Prairie Island Nuclear Generating Plant

**Response to Request for Additional Information Regarding
Report NSPLMI-96001, Individual Plant Examination of External Events (IPEEE),
Related to Generic Letter 88-20**

Response to RAI Seismic Questions

PRAIRIE ISLAND SEISMIC IPEEE RAI RESPONSES

Figure 1. Success Block Diagram

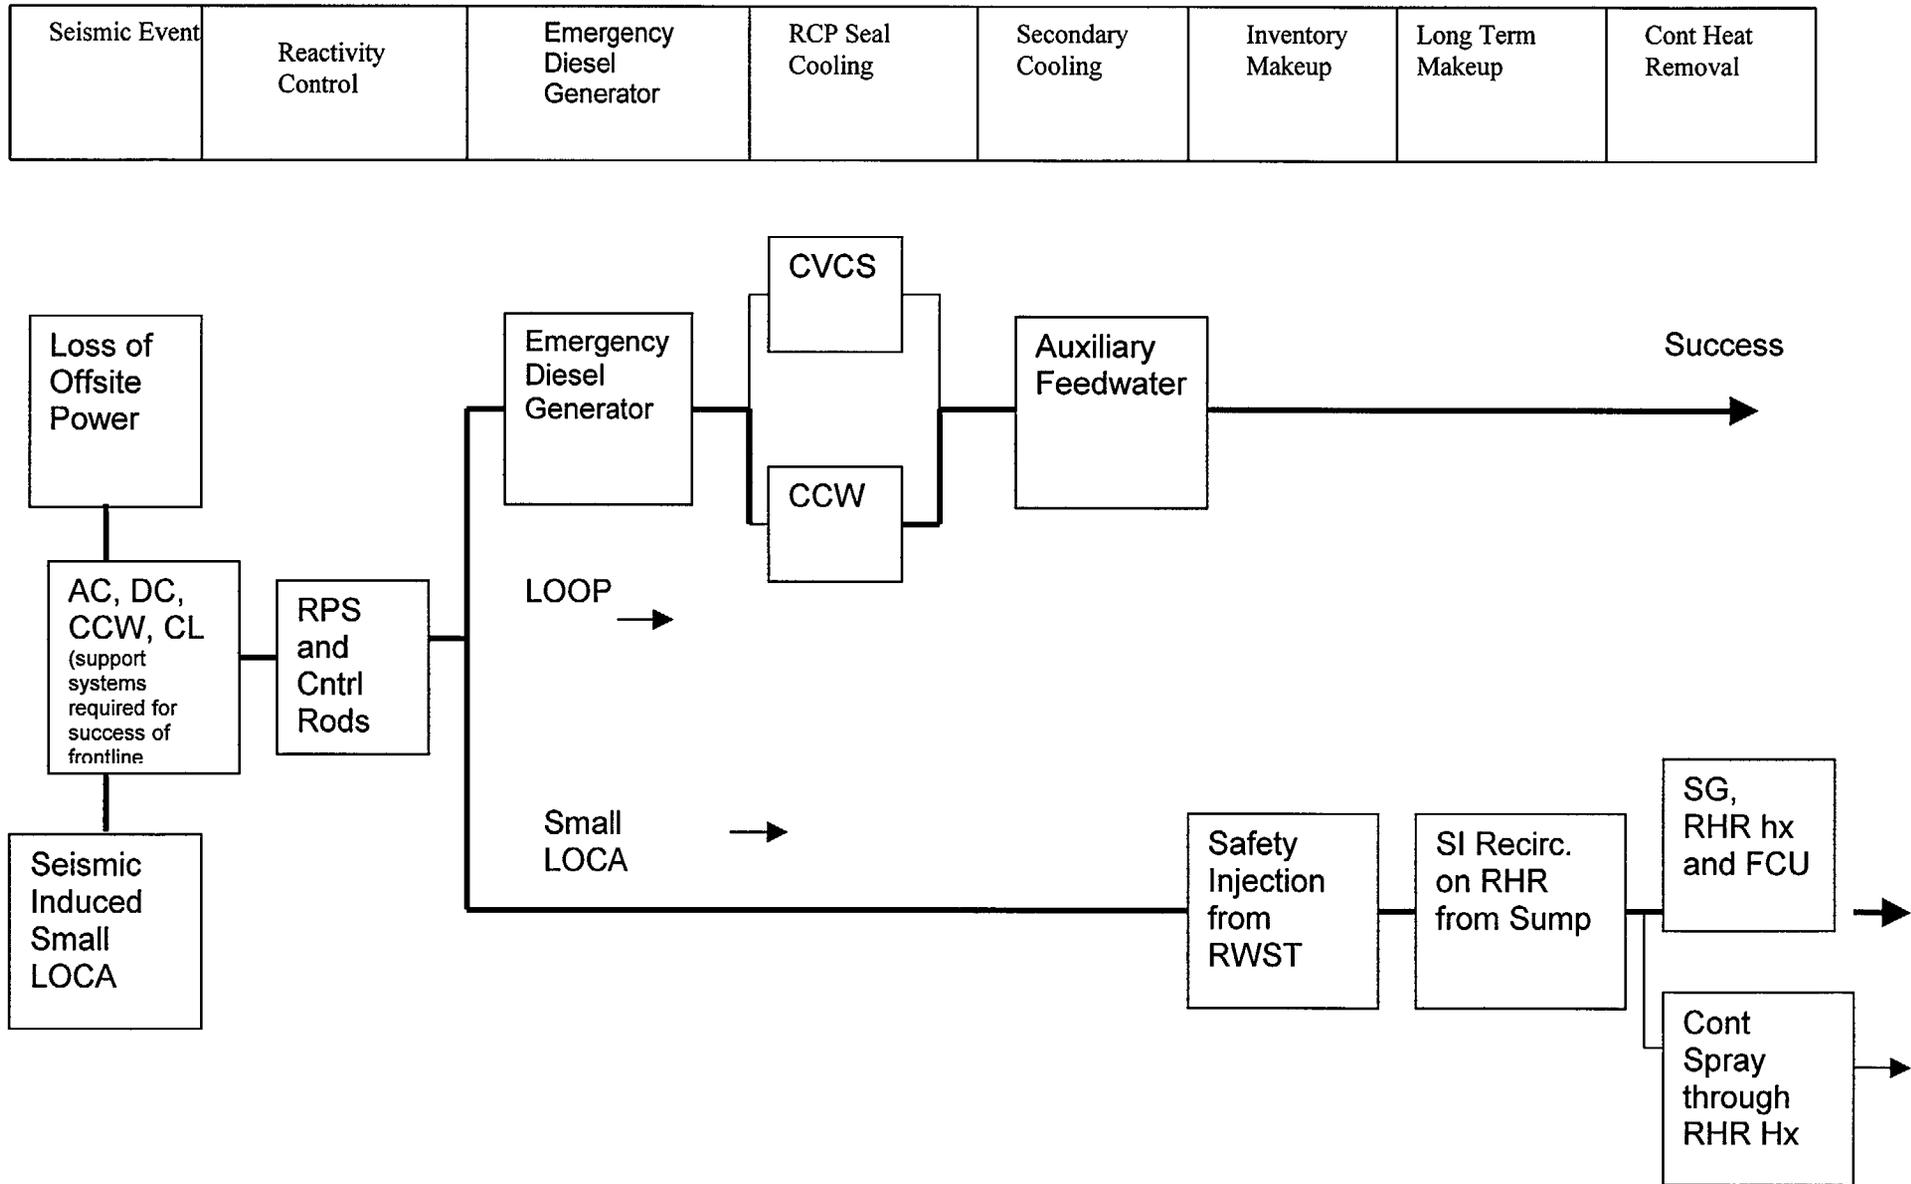
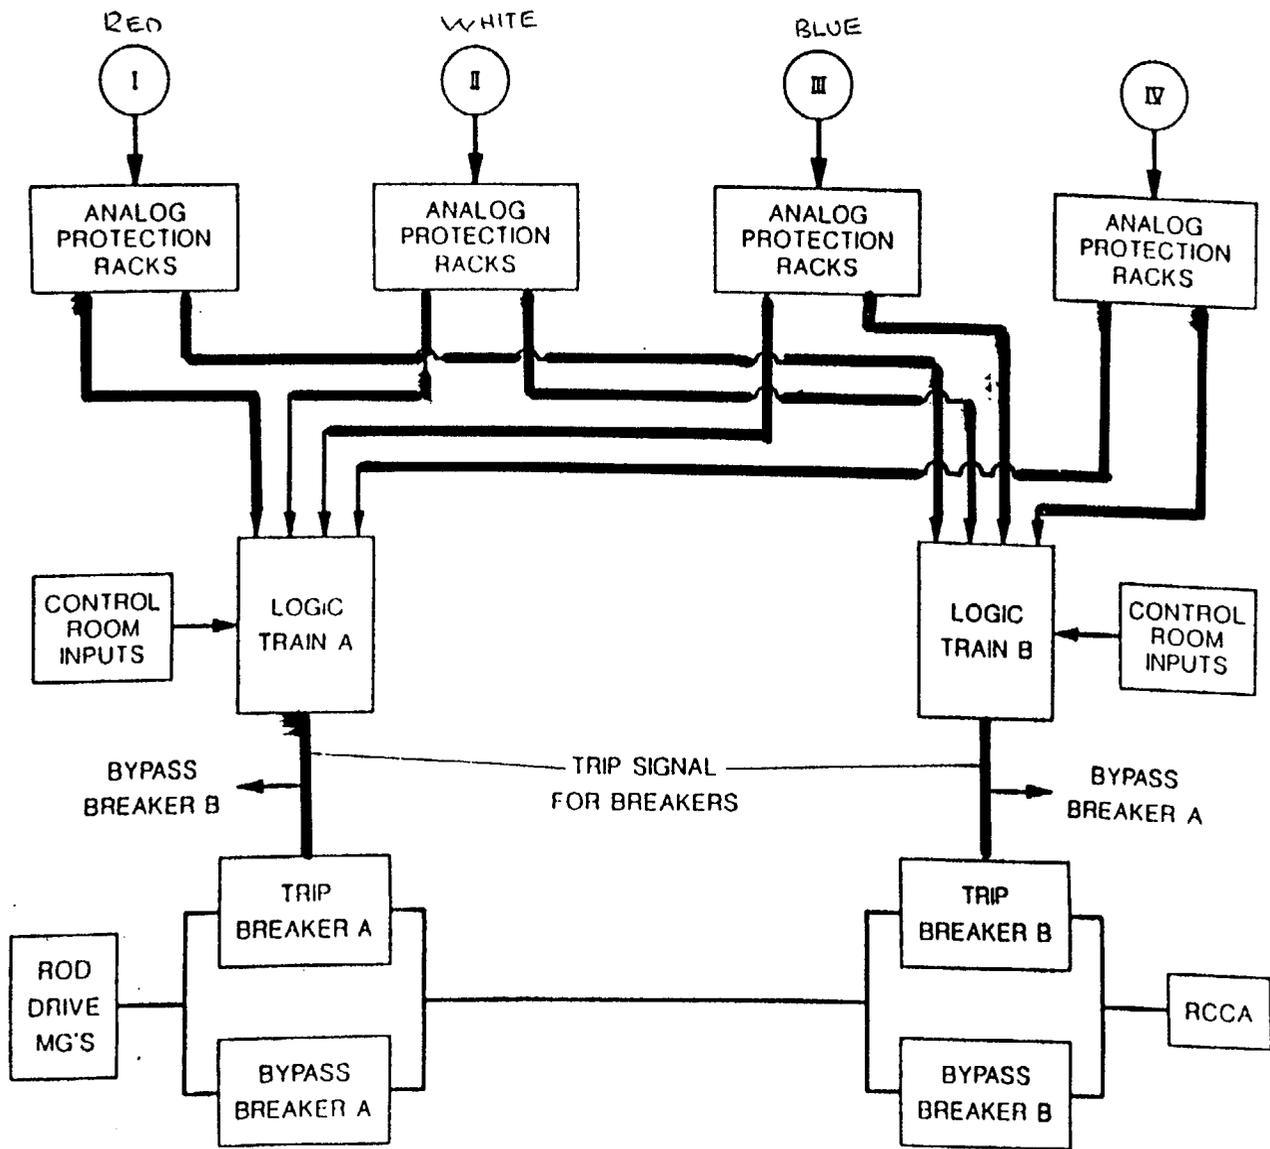
success path selection of structures, systems, and components are not consistent with those described in EPRI NP-6041-SL. Success path logic diagrams (SPLDs) were not provided in the IPEEE submittal; although equipment for important safety functions were identified and discussed, specific success paths that could bring the plant to a safe shutdown condition were not identified. It is not clear whether the selected equipment can provide two success paths with sufficient redundancy and diversity.

Please provide information on success path development and system selection consistent with that described in EPRI NP-6041-SL. Please include in the discussion the development and identification of the success paths, the systems and equipment included in the Safe Shutdown Equipment List (SSEL) and their safety functions, and the isolation of systems that are excluded from the SSEL (for example, successful isolation of the condensate storage tanks when the water source of the auxiliary feedwater (AFW) pumps is switched).

The success path block diagrams for loss of offsite power and for a small LOCA are shown in Figure 1. Table 1 lists the CSFs credited and identifies the preferred and alternate systems supporting these CSFs. It also provides the figure numbers (Figures 2 through 13) for the attached simplified line diagram of each system. The trains of major equipment credited in the seismic margins assessment are highlighted in the line diagrams. The simplified flow diagrams developed for the Internal Events PRA serve as a substitute for success path block diagrams. The preferred systems have at least two independent trains, as shown in the system line diagrams.

Figure 14

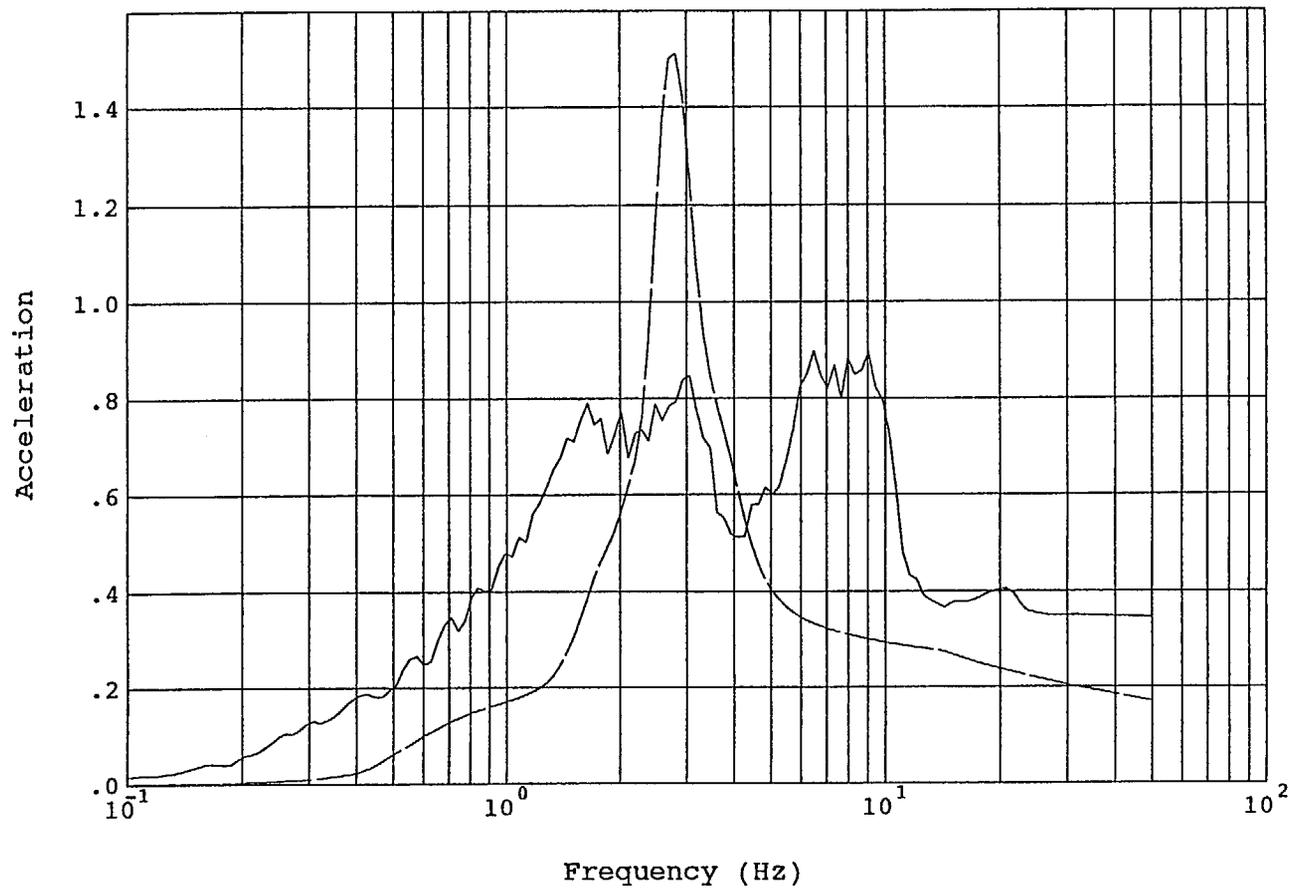
- 2/e) the comparisons of the design basis ground spectrum and in-structure response spectra (IRS) to the IPEEE 0.3g pga RLE ground spectrum and in-structure response spectra. If scaling is used, describe the scaling method. If new IRS are generated, describe the analyses performed to generate all significant RLE IRS.

5% damped Reactor-Auxiliary-Turbine Building RLE IRS are compared to 5%

damped SSE IRS used for resolution of USI A-46 at selected building locations containing essential equipment in Figures 14 to 25. Only horizontal IRS are compared since vertical motions typically do not have significant impact on the IPEEE seismic evaluations.
